5.1: Parks & Open Space Standards

We are proposing clarification of Section 5 in the PD, addressing open space and tree-save (trees that cannot be removed). "Section 5.1: Open Space, B" of the approved PD states that "surpluses in the minimum area of any individual open space may be applied to deficiencies in other required open spaces." We have proposed the addition of language in "Section 5.2: Trees, D" to apply this same concept to tree-save areas, allowing for surpluses in any individual tree-save area to be applied to deficiencies in other required tree-save areas, so long as the total acreage of tree-save is maintained.

FIGURE 5.1
OPEN SPACE PLAN

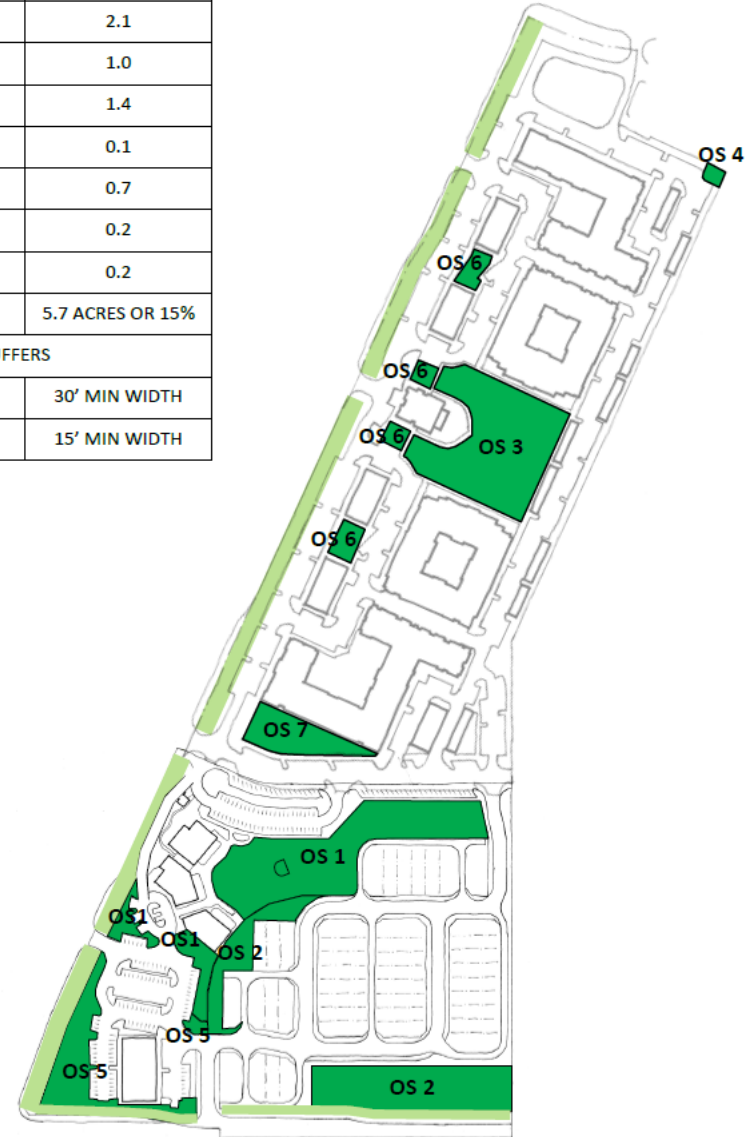
The approved open space standards require OS 2 to have a tree-save area of at least 75% of the joint open space (0.75 acres) and OS 5 to have a tree-save area covering at least 60% of the open space (0.42 acres) for a total of 1.17 acres of tree-save area.

In order to compensate for this shortfall, the PD allows for surpluses in open space in any individual open space to be applied to deficiencies in others, so OS 2 (the single-family home lot) can accommodate. The intent is for OS 2 to also accommodate the shortfall in OS 5's tree-save area.

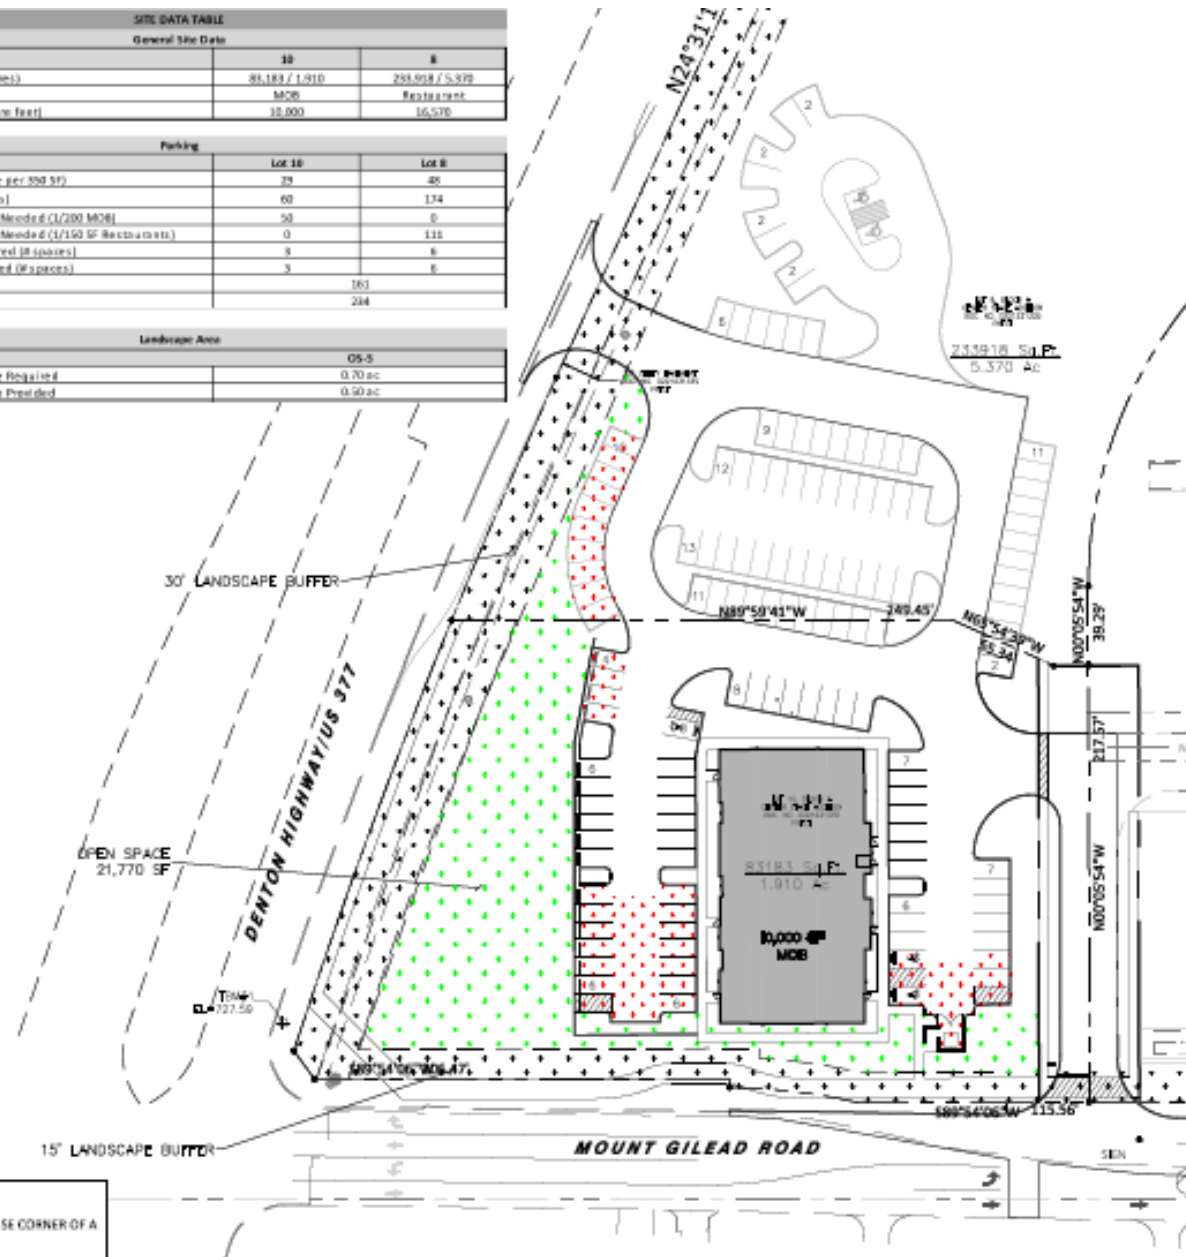
Due to fire truck access and parking needs both for the medical office building and for the 3 restaurants, while maintaining as much open space and tree save as possible, this configuration for the medical office building is the most ideal and came after multiple iterations in collaboration with City staff.

The medical office building, located in OS 5, in this configuration, can provide 0.50 acres of open space and 0.30 acres of tree-save, creating shortfalls of 0.20 acres of open space and 0.12 acres of tree-save area.

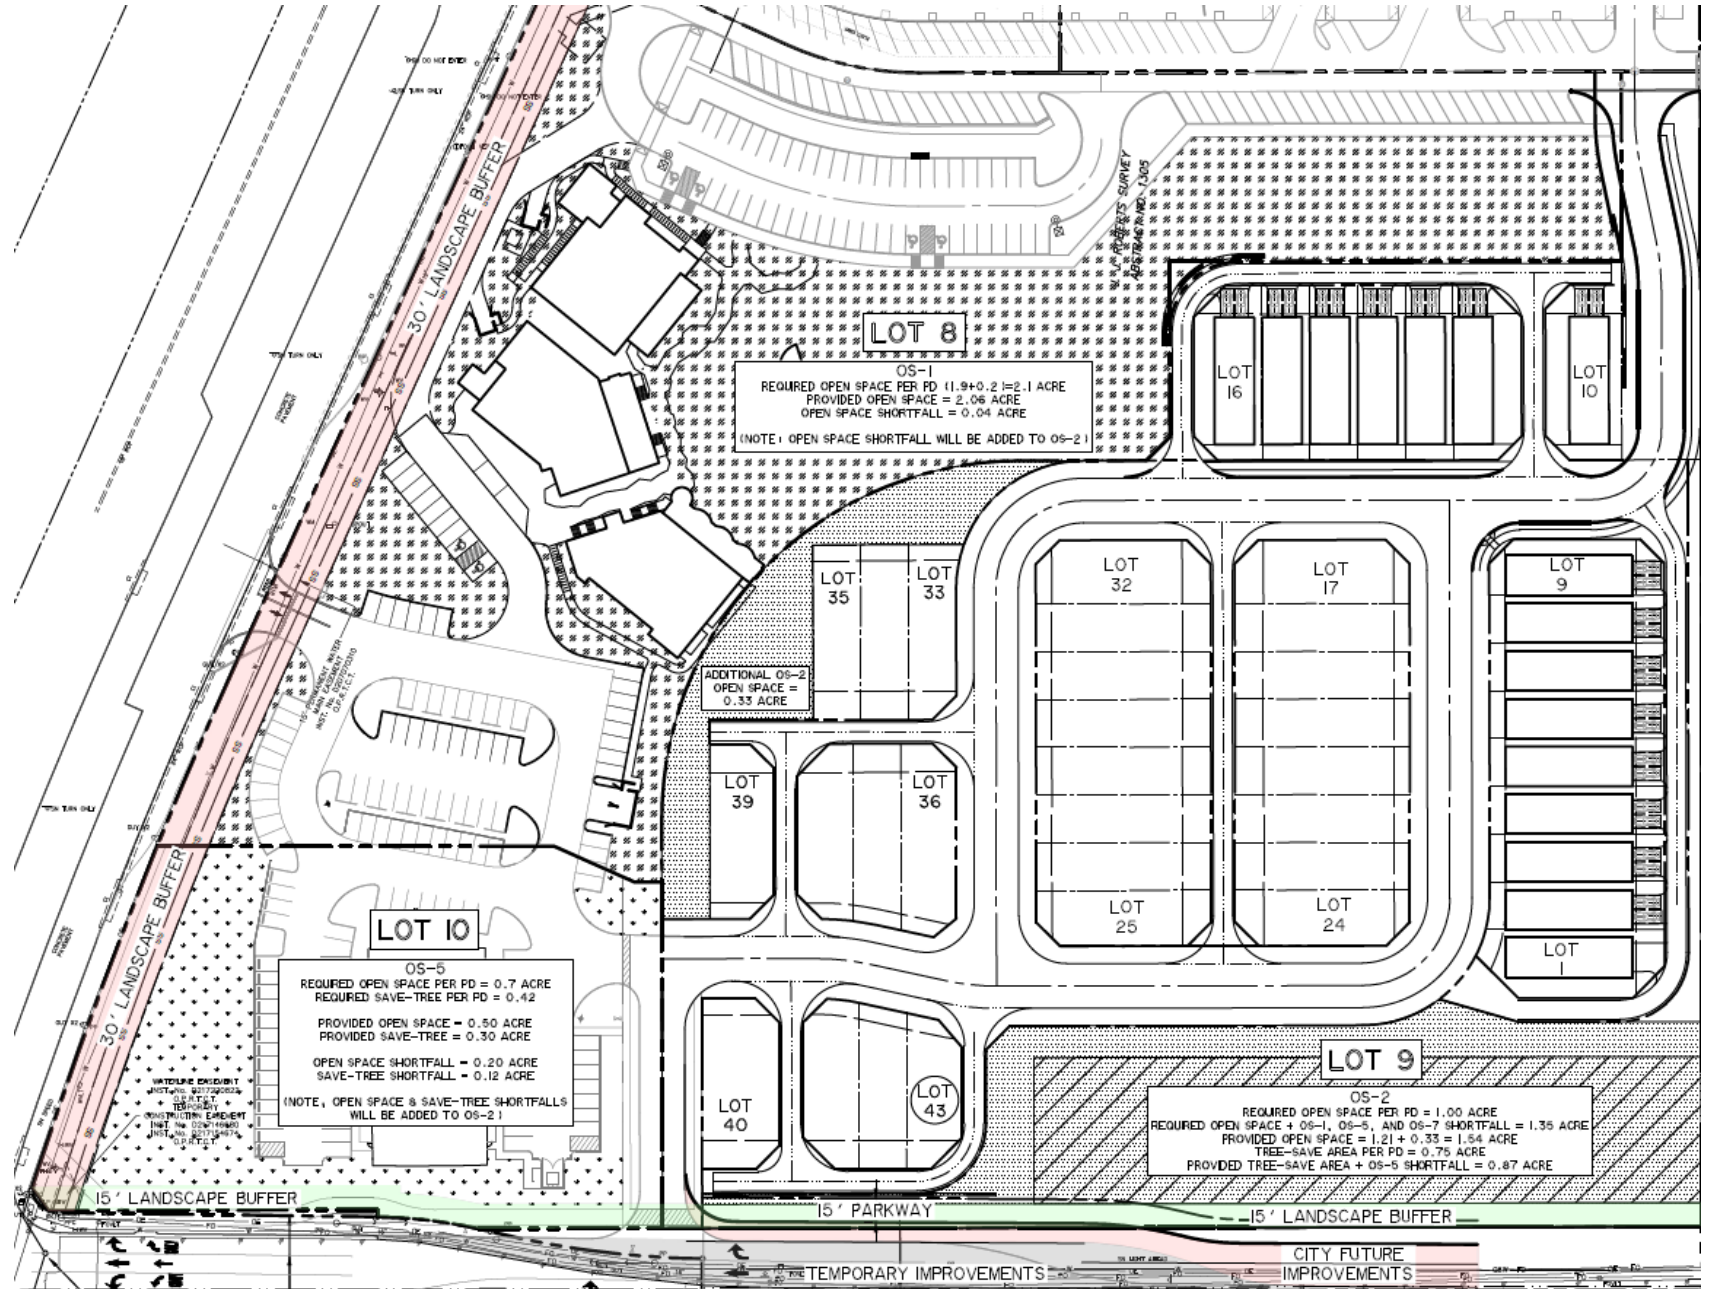
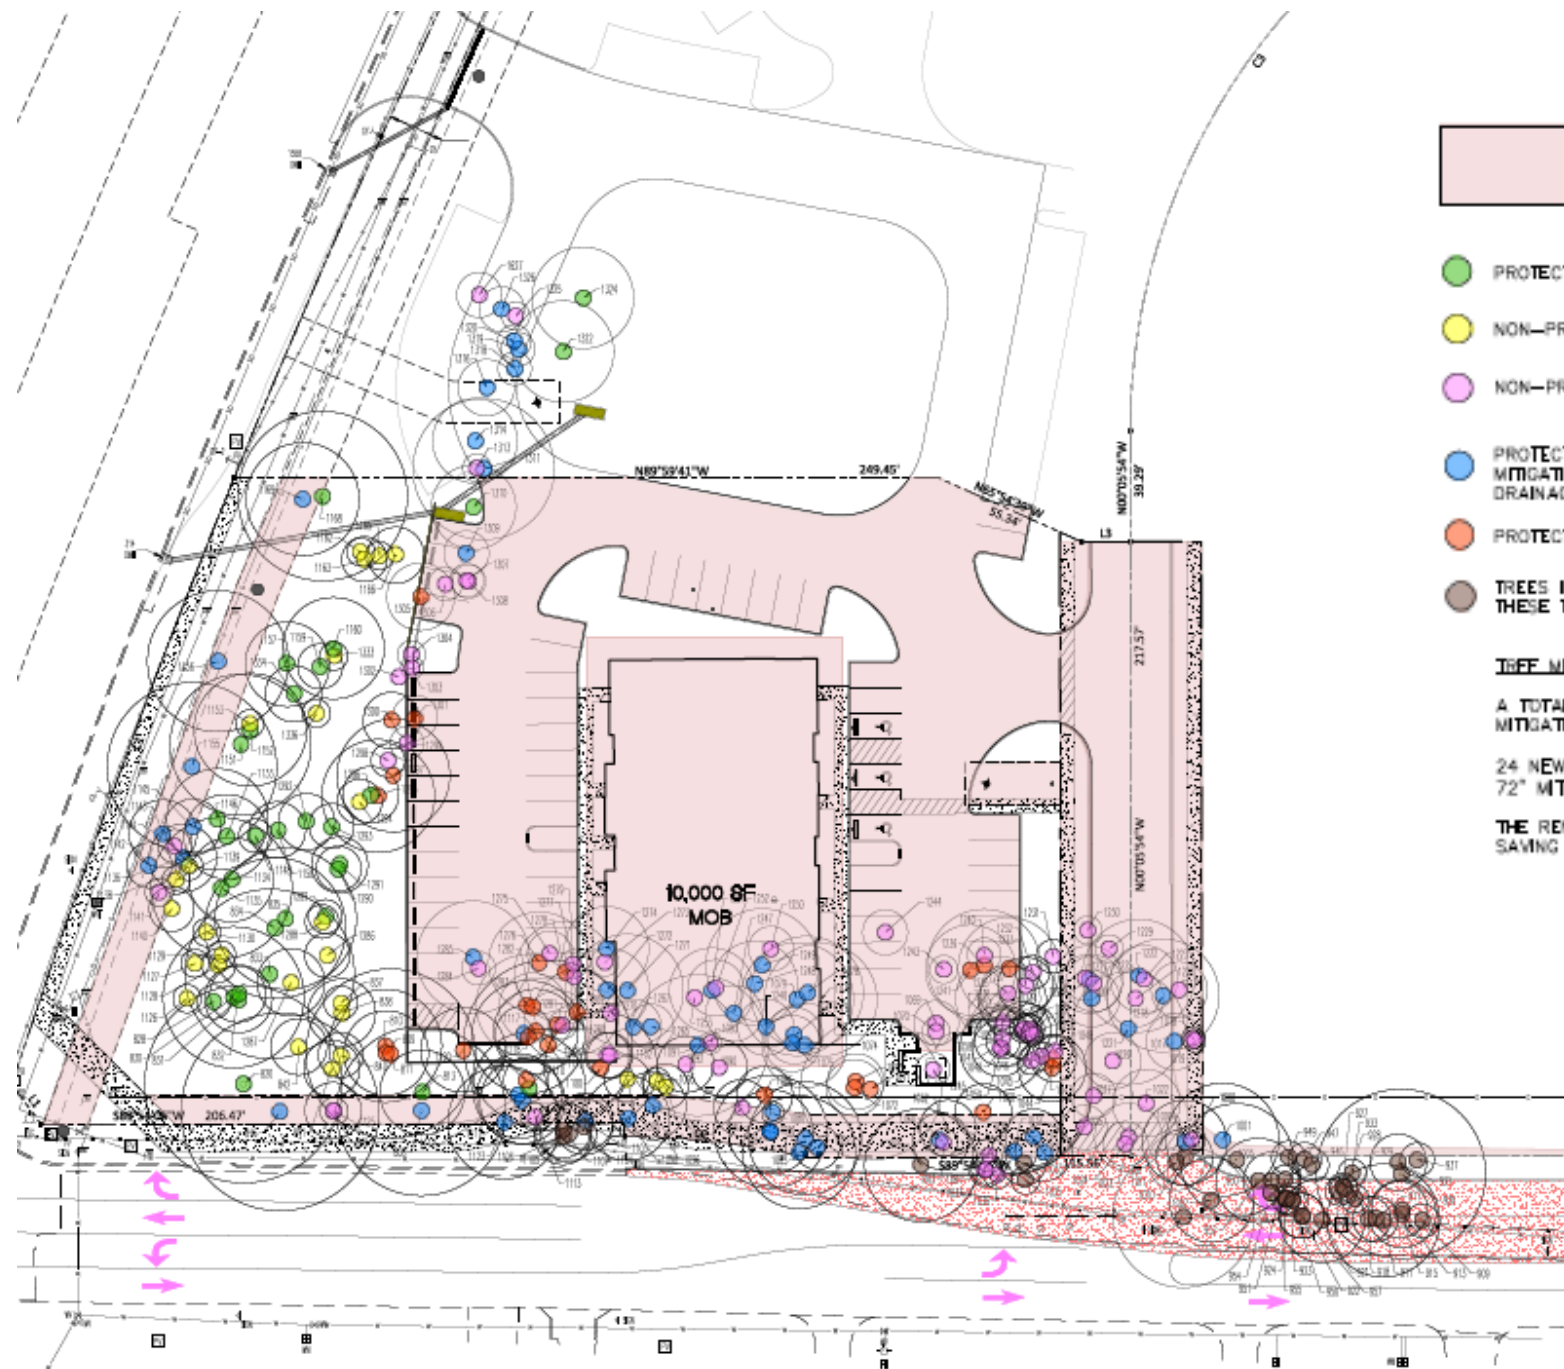
OS 2 (within Lot 9) is required by the PD to have at least 1.0 acre of open space and 0.75 acres of tree-save area. In order to accommodate open space shortfalls in OS 5 (Lot 10) of 0.20 acres, in OS 1 (Lot 8) of 0.04 acres and in OS 7 (Lot 7, north of Lot 8) of 0.11 acres, the new required open space for OS 2 is 1.35 acres. In order to accommodate the tree-save shortfall in OS 5 of 0.12 acres, the new required tree-save area in OS 2 is 0.87 acres. This plan shows 1.54 acres of open space and 0.87 acres of tree-save area provided in OS 2, arriving at the same required total of 1.17 acres.

TIFF MITIGATION

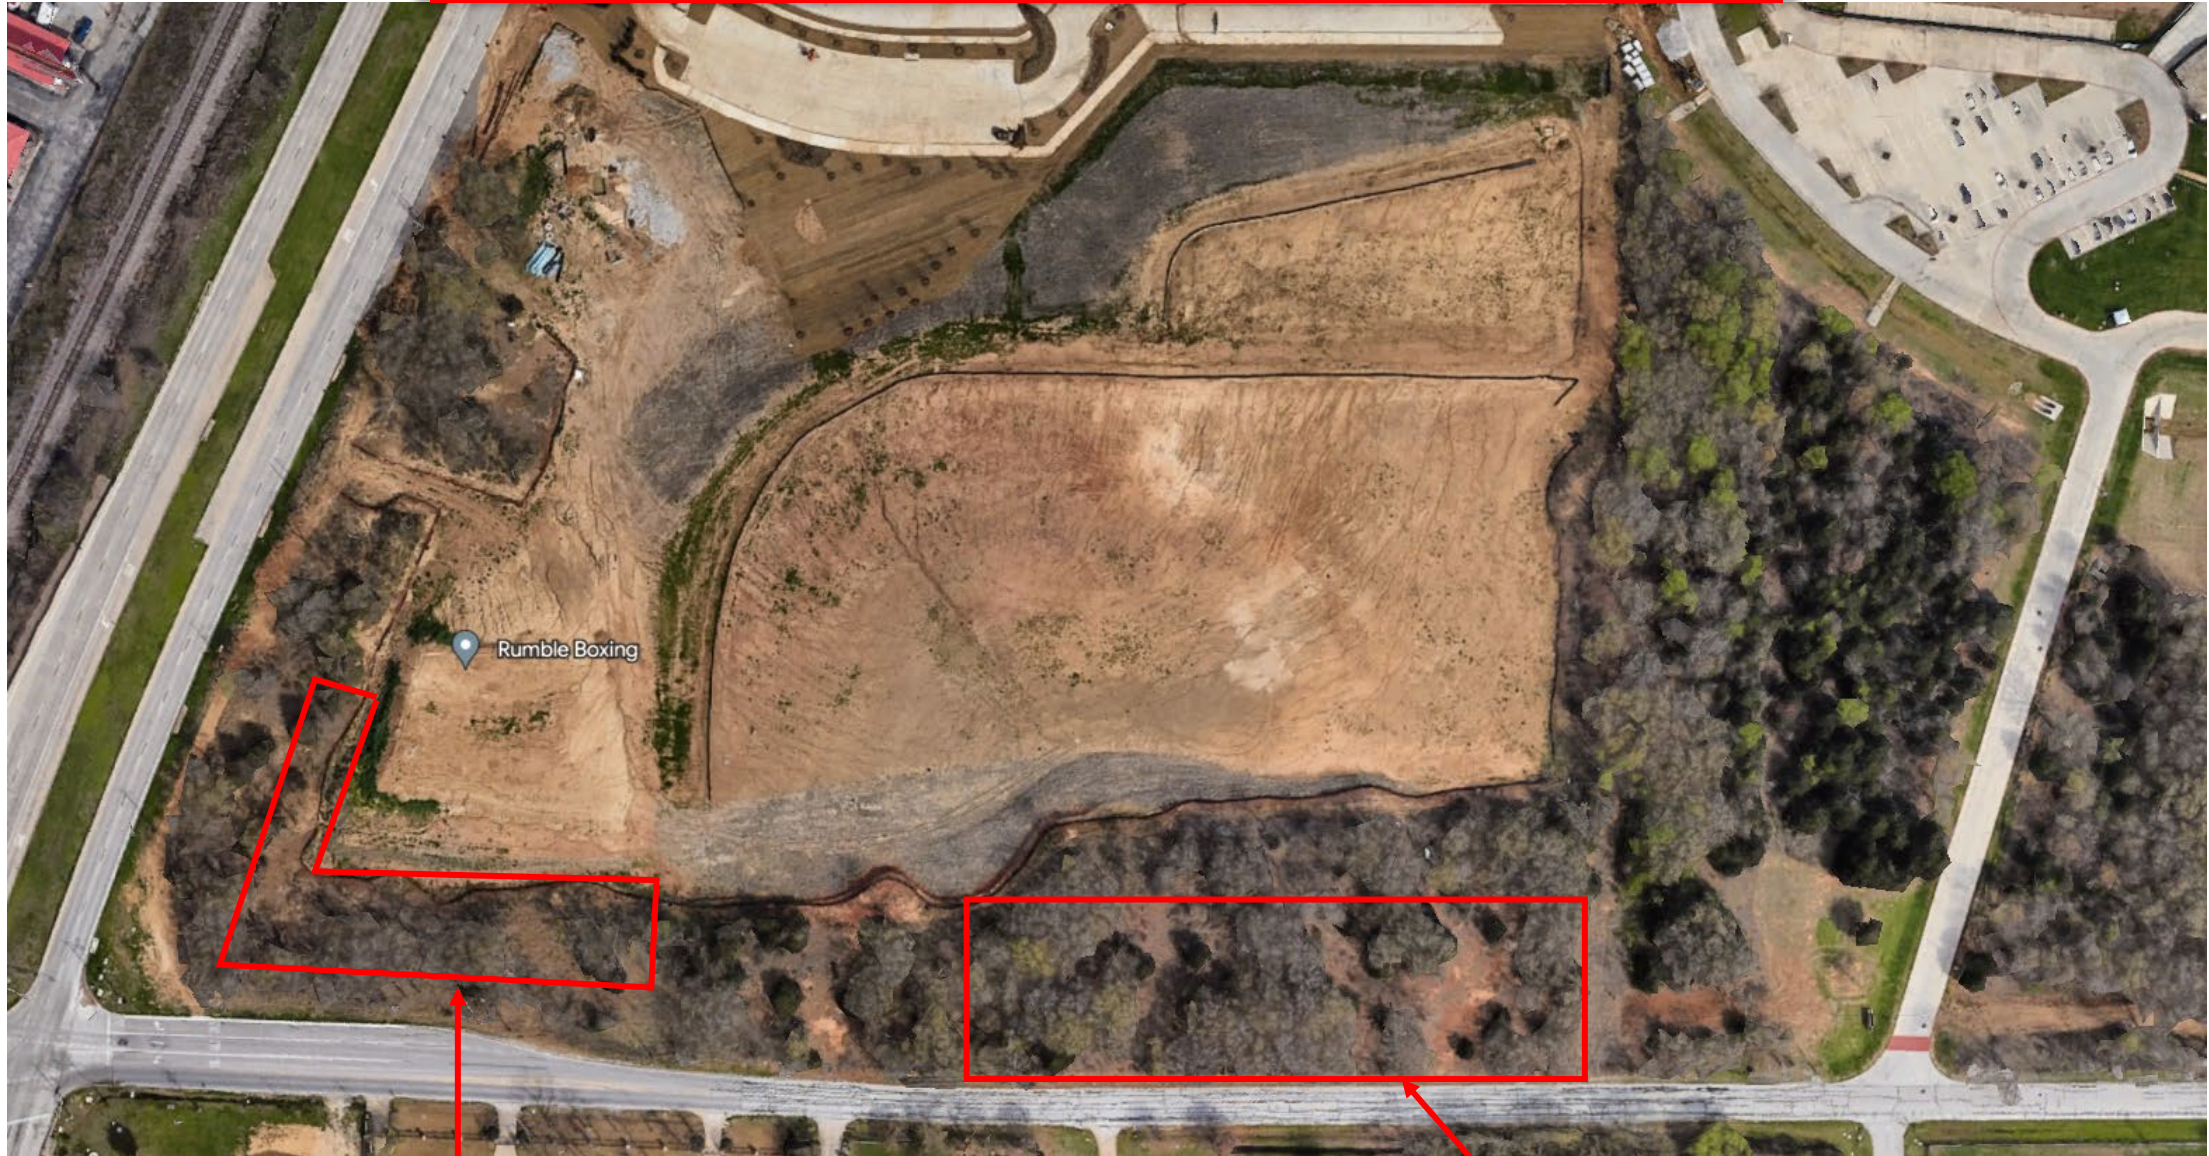
A TOTAL OF 198 CALIPER INCHES ARE REQUIRED TO BE MITIGATED. FOLLOWING IS HOW MITIGATION WILL BE ACHIEVED:

24 NEW 3" CALIPER TREES WILL BE PLANTED.
72" MITIGATION.

THE REMAINING REQUIRED MITIGATION WILL BE ACHIEVED BY SAVING EXISTING TREES.

This exhibit shows locations of trees to be saved and trees to be removed in connection with medical office building development.
